ICC A117.1 Comments on 2nd Draft

**Proposal list to the 2017 A117.1 for the 2023 edition –
03-30-2025**

Proposal list to the 2017 A117.1 for the 2023 edition – 2nd draft comments

FIGURE 307.4
REDUCED VERTICAL CLEARANCE

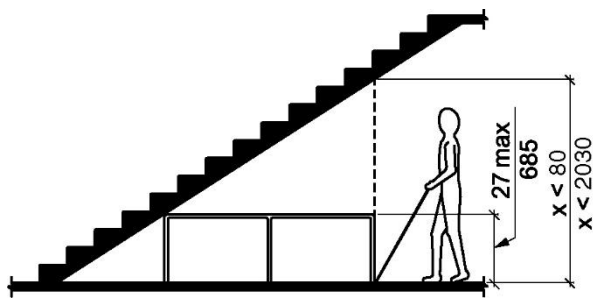
The code user would go to Section 307.4, Vertical Clearance, to figure out what they may want for a minimum door height. *We recognize this section is now called Headroom Clearance.*

Presuming Figure 307.4 is remaining the same but for renaming it headroom clearance, that

illustration and the exception allows doors closers/stops to be 78” above the floor. The current proposed modification may get interpreted by some inspectors that doors must also be 80” in height to make rooms for the door closers/stops when attached to them, but A117.1 does not specifically say a door must be a minimum height of 80 inches. The proposed changes in comment E-01-2023-AM simply makes it more difficult to read and understand what is being required. We believe the current A117.1 language is clearer and recommend reverting back to it.

307.4

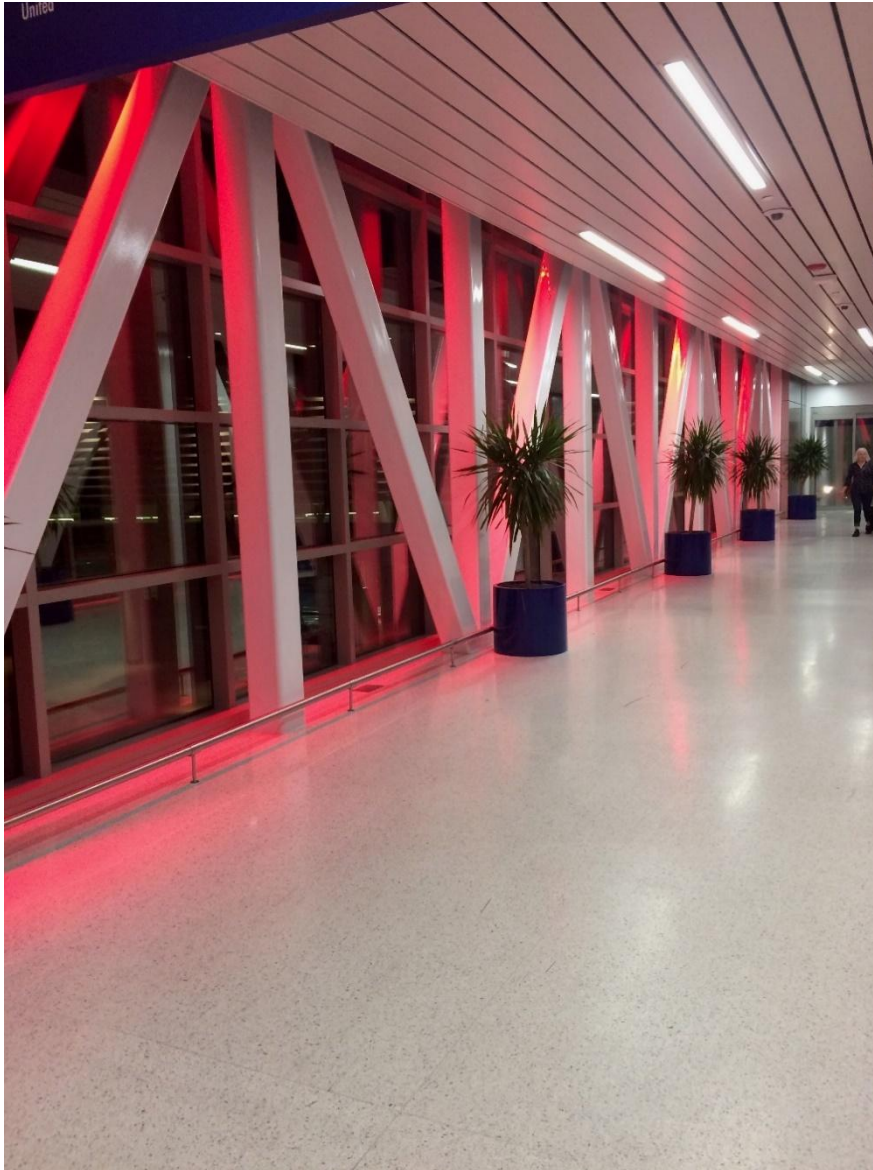
03-09– 2021 Ballot Comment 3

Proponent: Kimberly Paarlberg, ICC

FIGURE 505.10.1
TOP AND BOTTOM HANDRAIL EXTENSION AT RAMPS

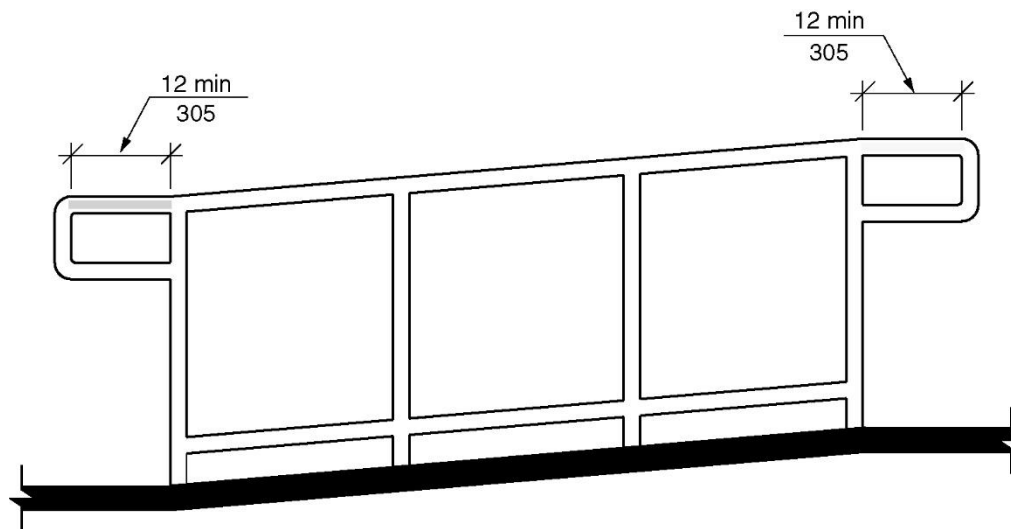
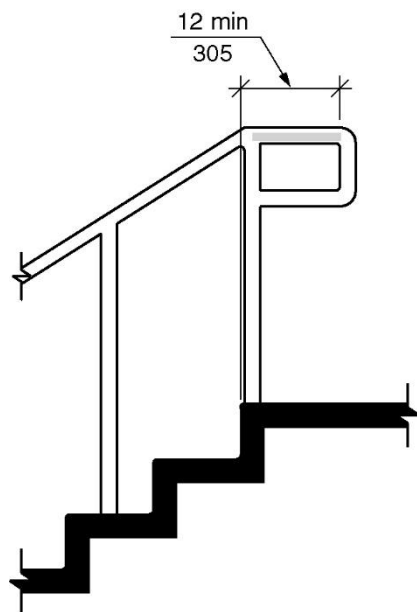
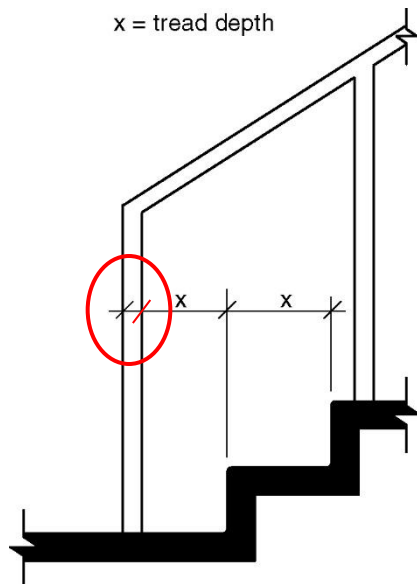
REASON: It is very common for stairs and ramps in juxtaposition to leave no room for typical handrail extensions but it is often feasible to make the handrail continuous at the intersection of the ramp and stair just as it is to provide continuity at adjoining ramp runs and adjoining flights of stairs.

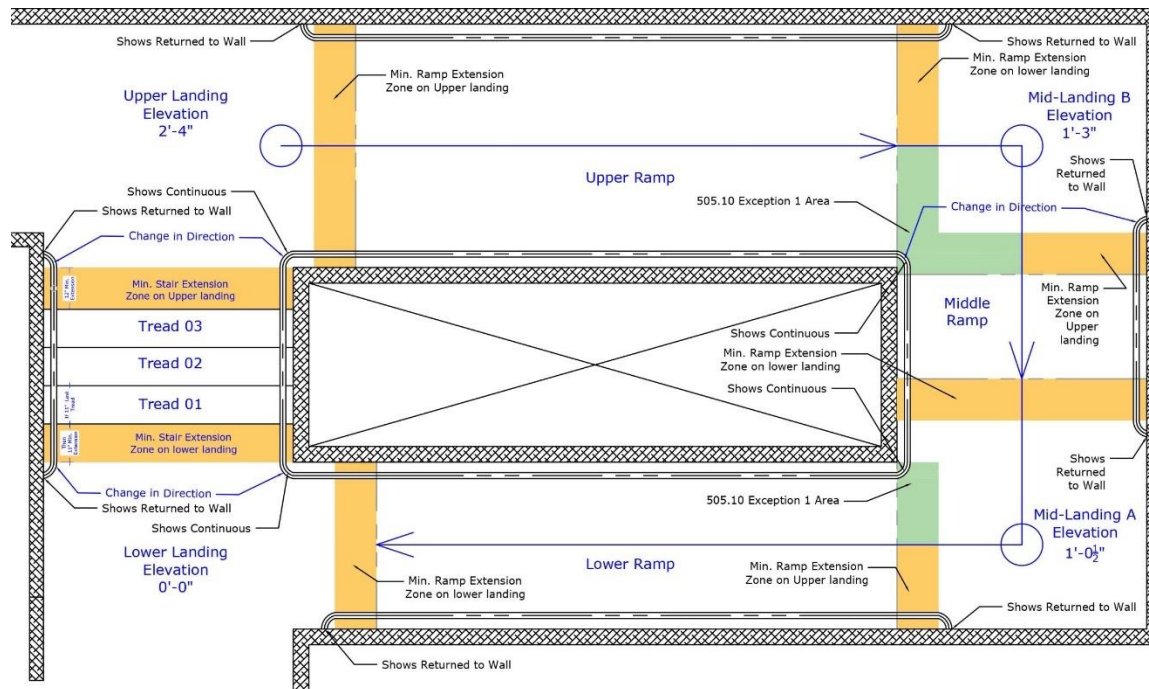
Let's first look at the last sentence in 505.10.1, which only allows a ramp handrail extension to connect and be continuous to another ramp, or it must return to a wall, guard, or landing surface. It defines no option to be continuous to another handrail of a stair flight, even after exceeding the minimum extension requirement. This however is done all the time in the field, and to date has not been called out or failed that I am aware of, except when the minimum extensions are not

completed before connecting the handrails. However the text is the text and should be discussed at a minimum for intent and technically when splitting hairs is allowed or not.

In the last sentence in 505.10.2, which only allows the handrail extension at the top of a stair flight to connect and be continuous to another stair flight handrail, or it must return to a wall, guard, or landing surface. It clearly defines no option to be continuous to a handrail of a ramp, even after exceeding the minimum extension requirements for both the ramp and stair.

In the last sentence in 505.10.3, which only allows the handrail extension at the bottom of a stair flight to connect and be continuous to another stair flight handrail, or it must return to a wall, guard, or landing surface. It again defines no option, as does 505.10.2, to be continuous to a handrail of a ramp.
